# NOTICE OF PUBLIC HEARING Minor Variance

APPLICATION	HM/A-22:196	SUBJECT	120 FLATT AVENUE, HAMILTON
NO.:		PROPERTY:	
ZONE:	"C" (Urban Protected	ZONING BY-	Zoning By-law 6593, as Amended
	Residential, etc.)	LAW:	21-137

**PURPOSE & EFFECT:** So as to permit the development of a one-storey addition in the rear yard and the conversion of the existing single detached dwelling to contain a Secondary Dwelling Unit.

DRAWING NAME
Elevations

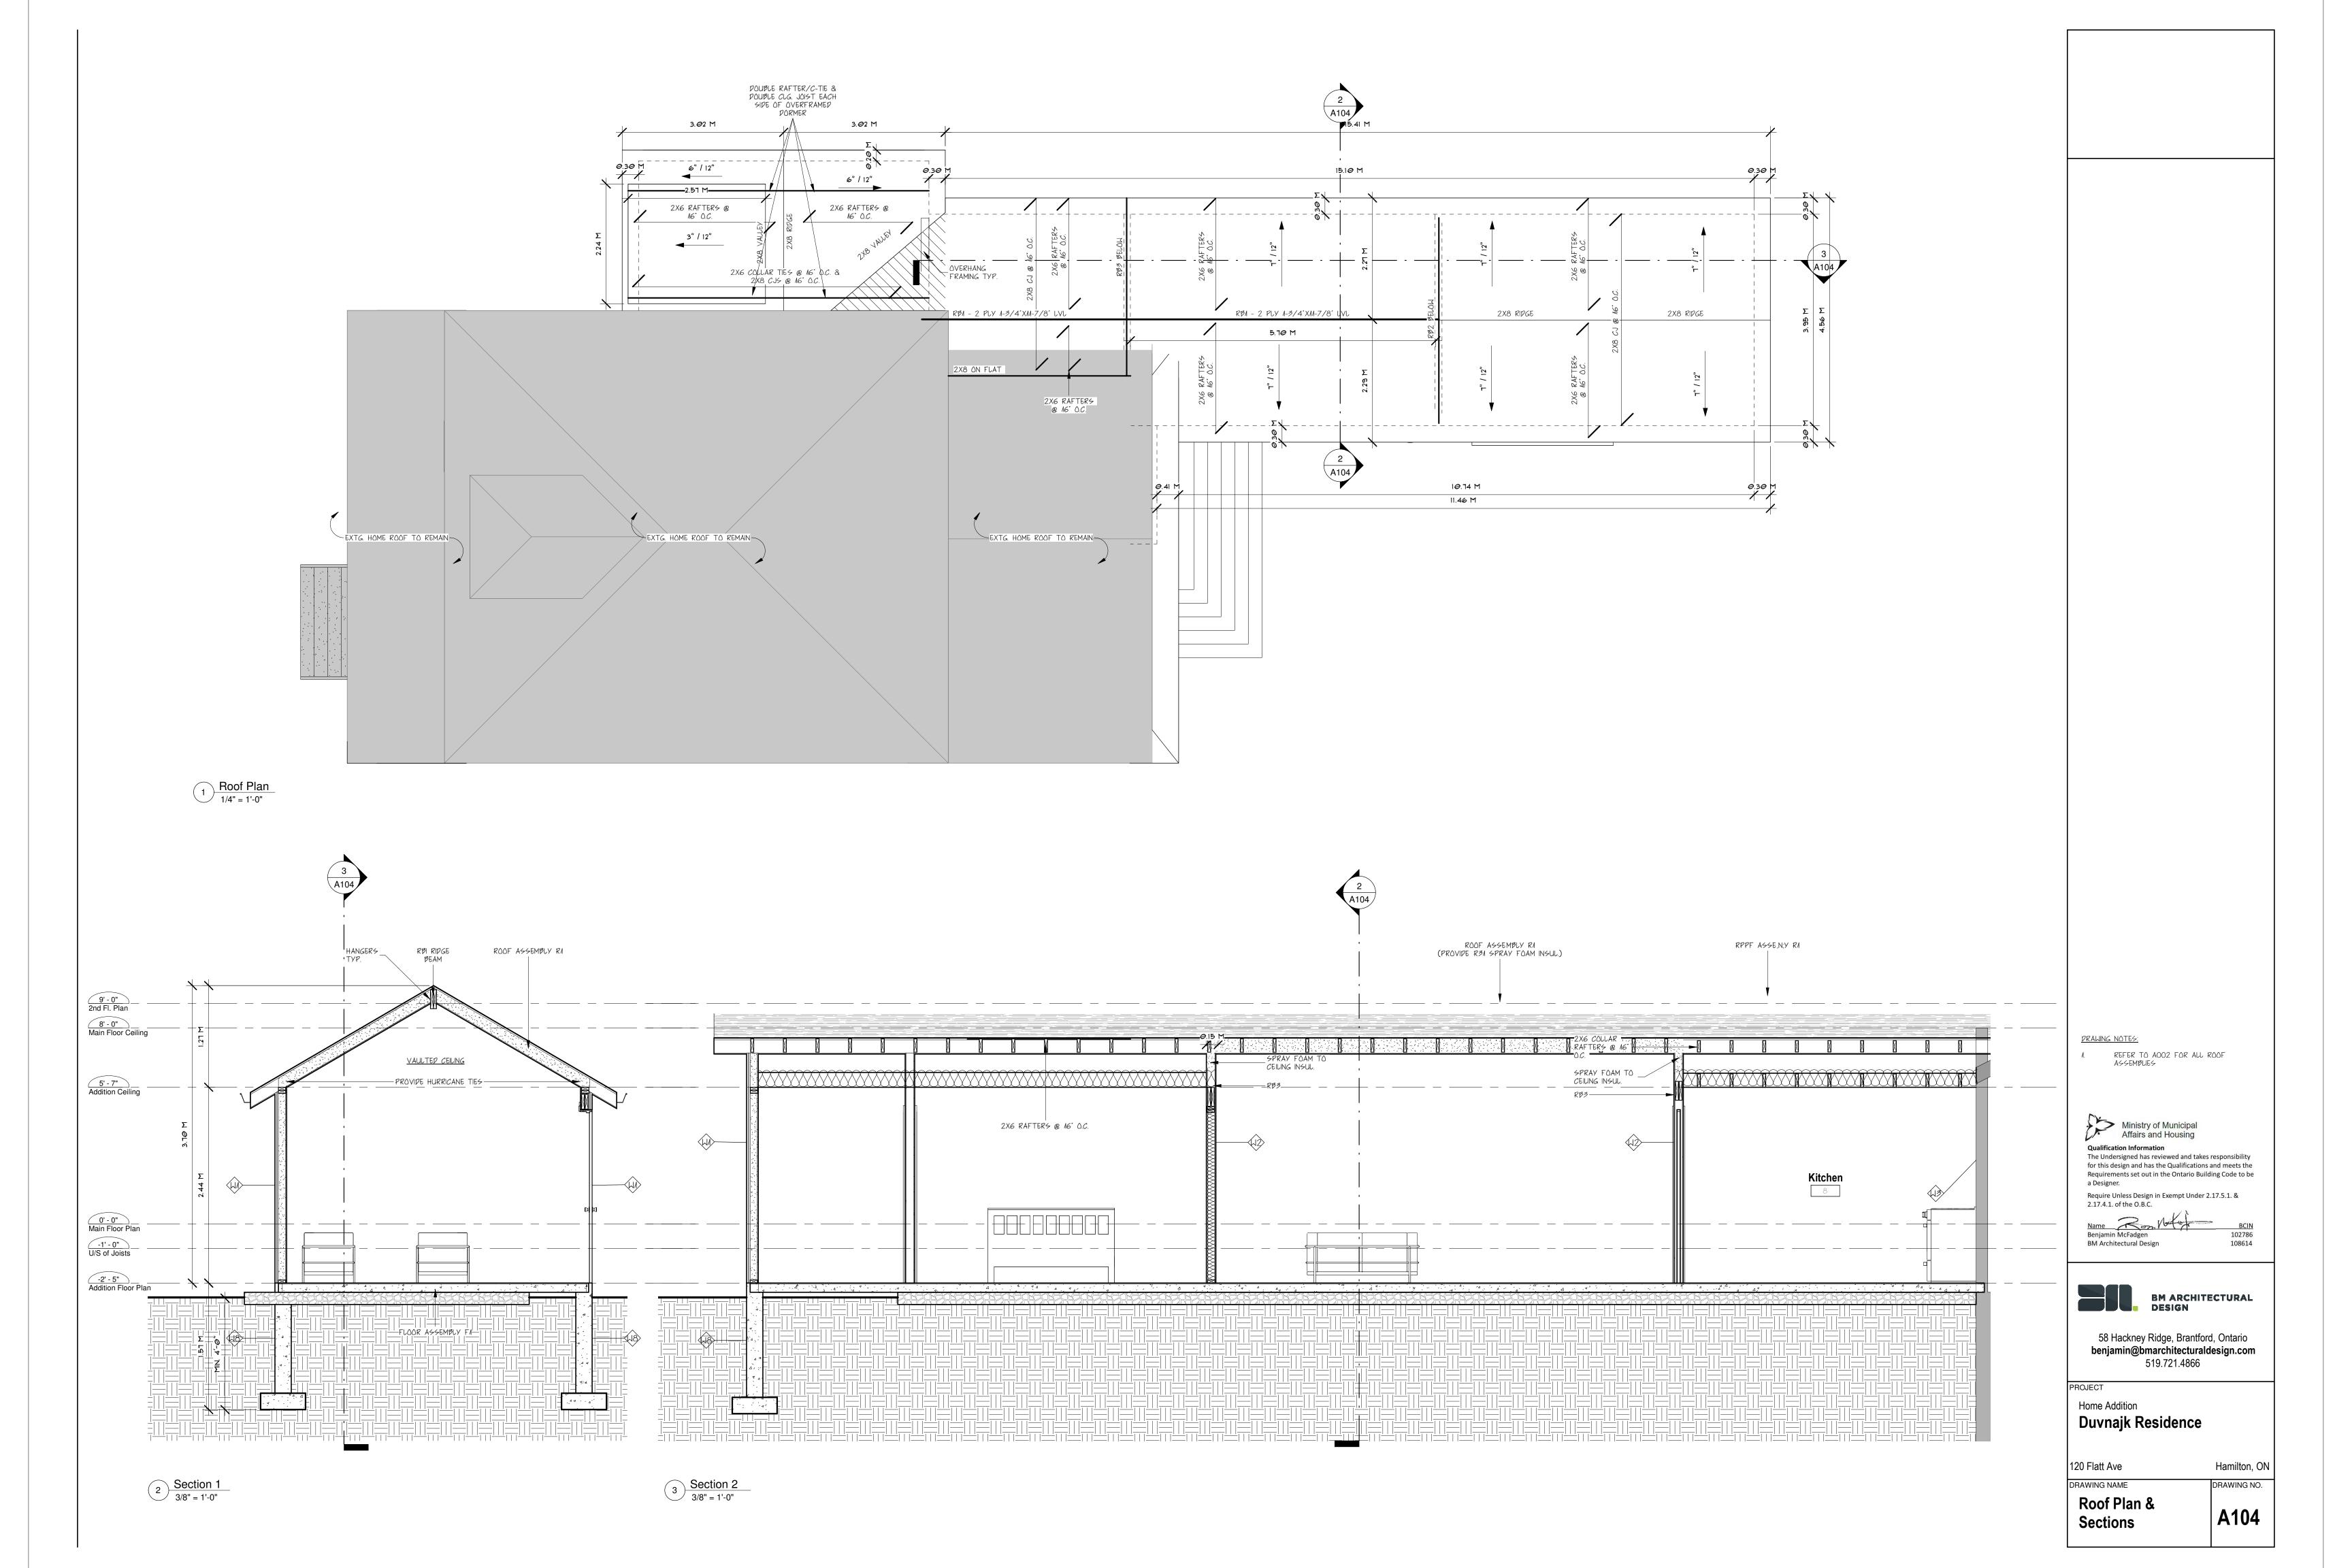
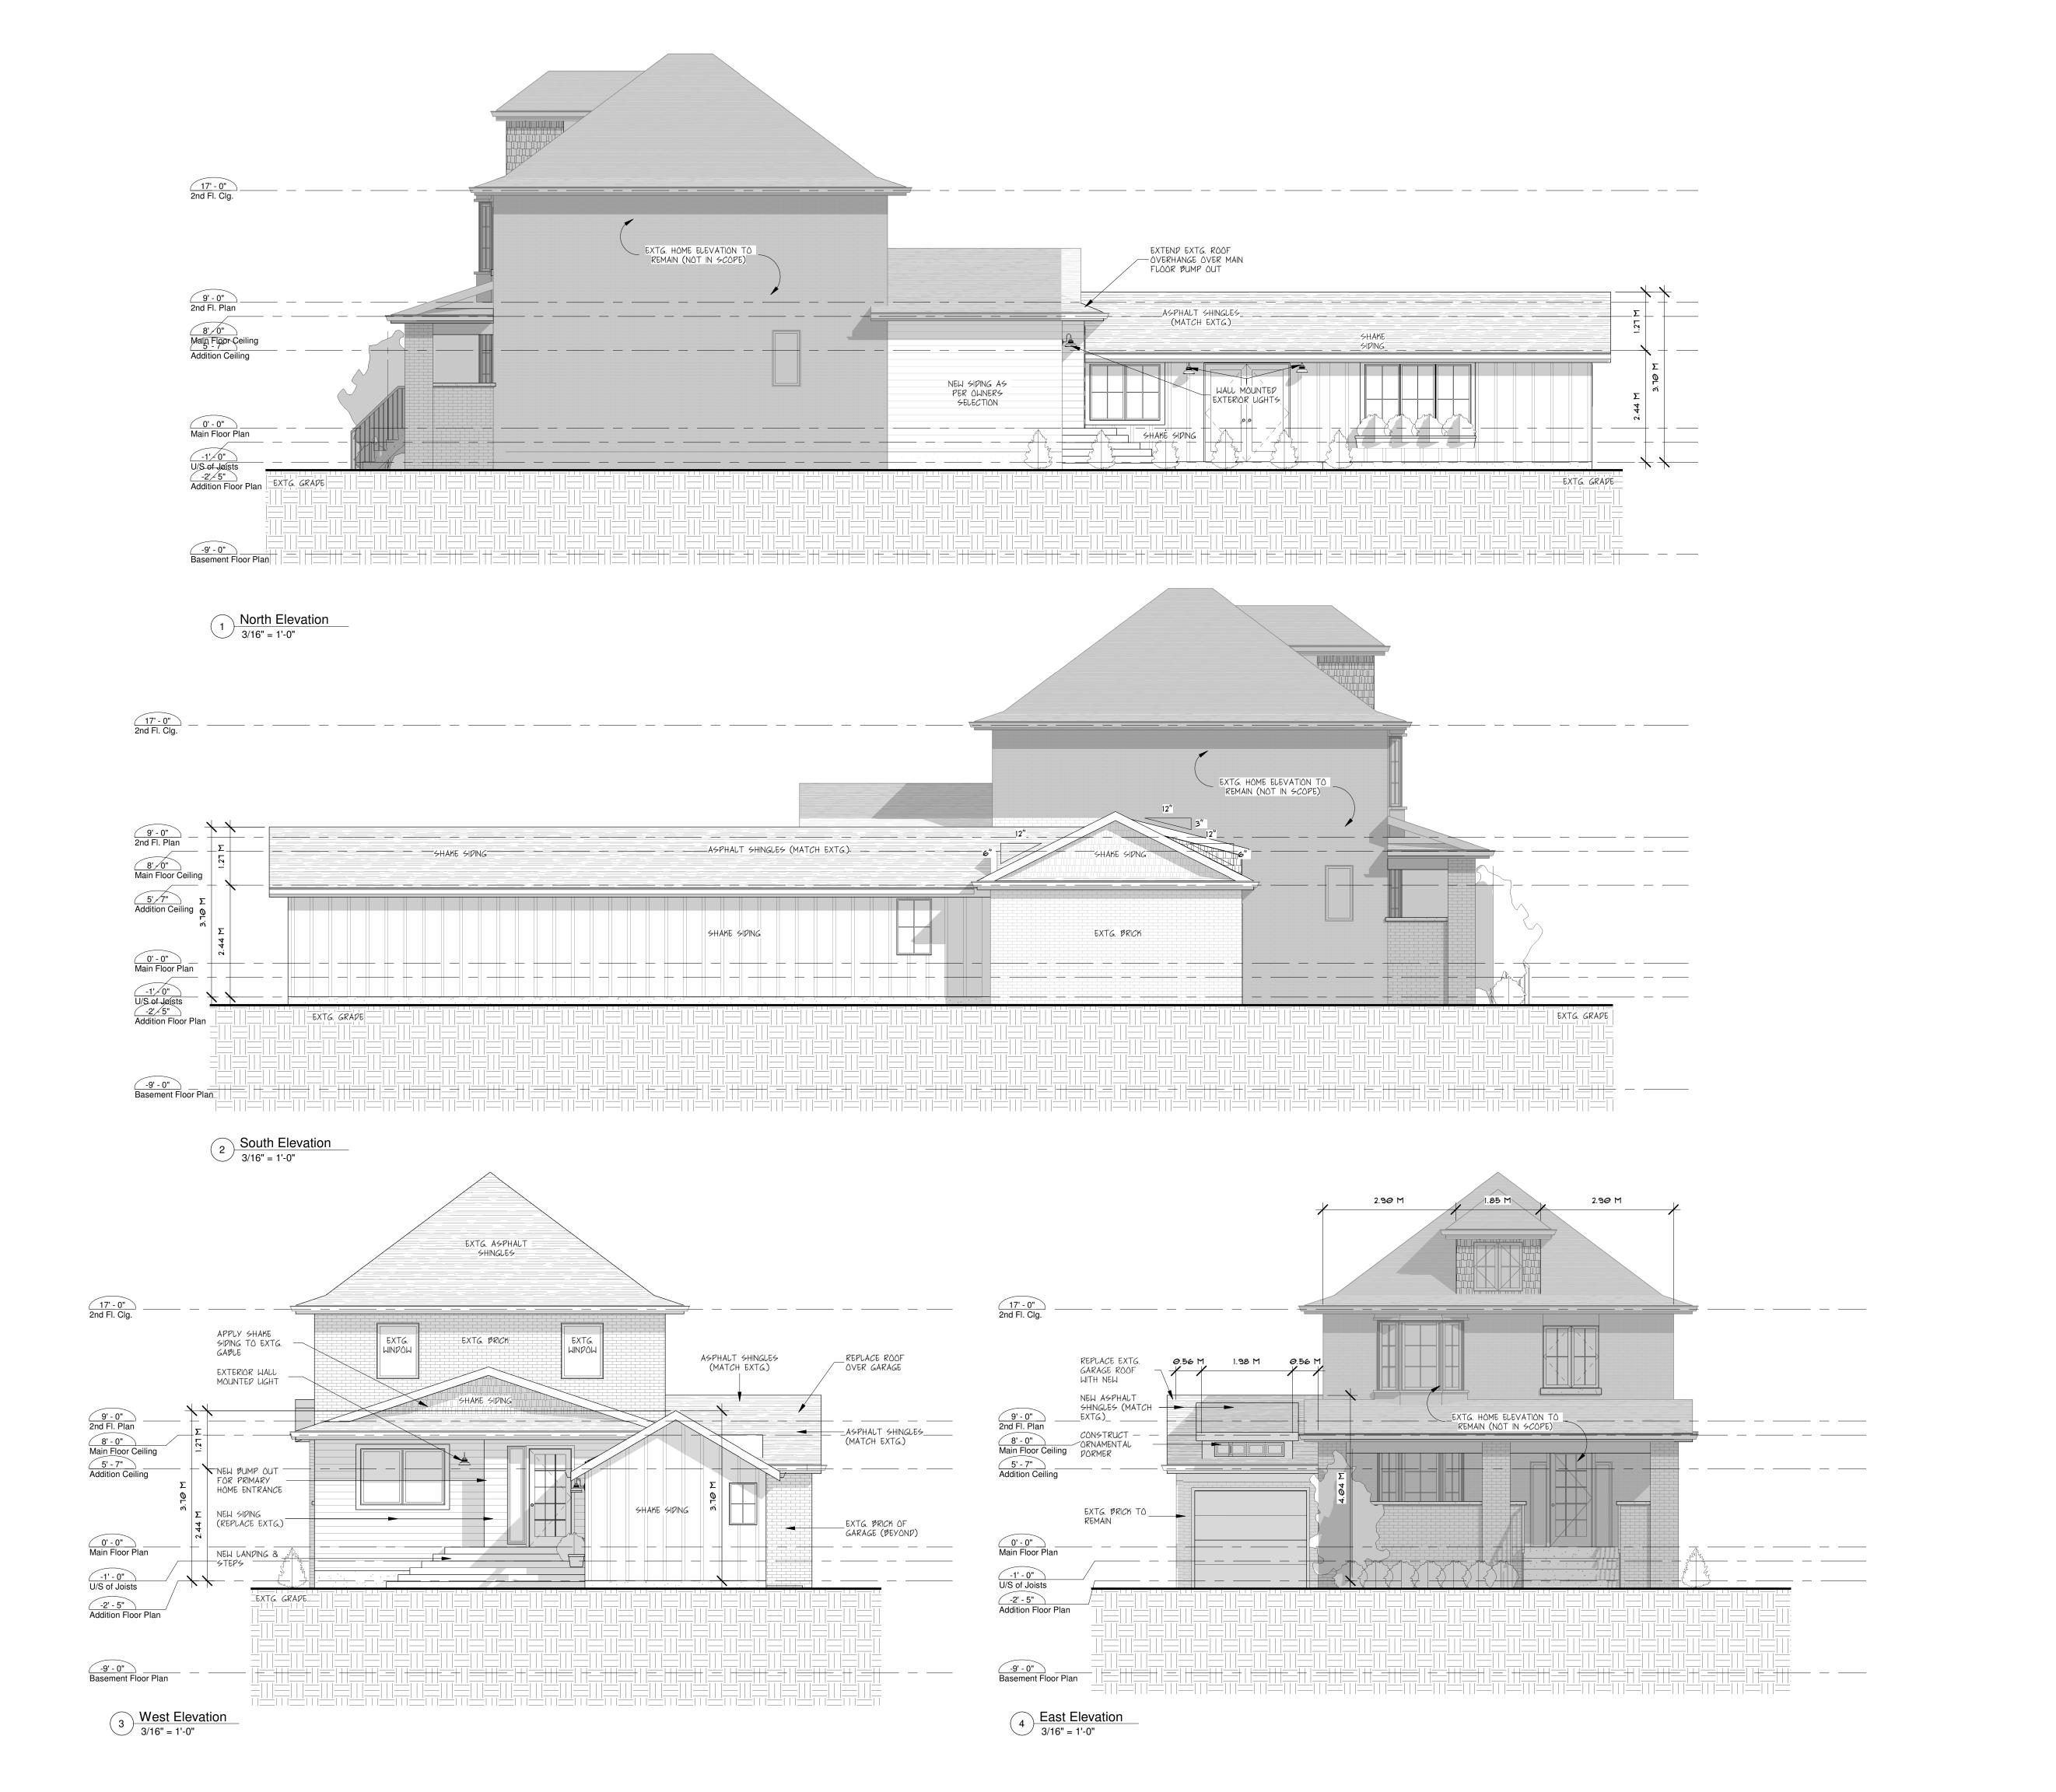
- 2. Please note that the submitted elevation drawings included as part of this application, indicate a building height of 3.70 metres for the proposed addition. However, the height indicated does not appear to indicate "Building Height" and "Grade" as established by Hamilton Zoning By-law No. 36920-92; therefore, the height of the proposed building cannot be confirmed to establish zoning compliance.
- 3. Please note that the specific projection of the proposed eaves/gutters was not indicated on the materials included as part of this application. Additional variances may be required if compliance with Section 18(3)(vi)(b) is not possible.
- 4. Construction of the proposed addition is subject to the issuance of a building permit in the normal manner. Be advised that Ontario Building Code regulations may require specific setbacks and construction types.
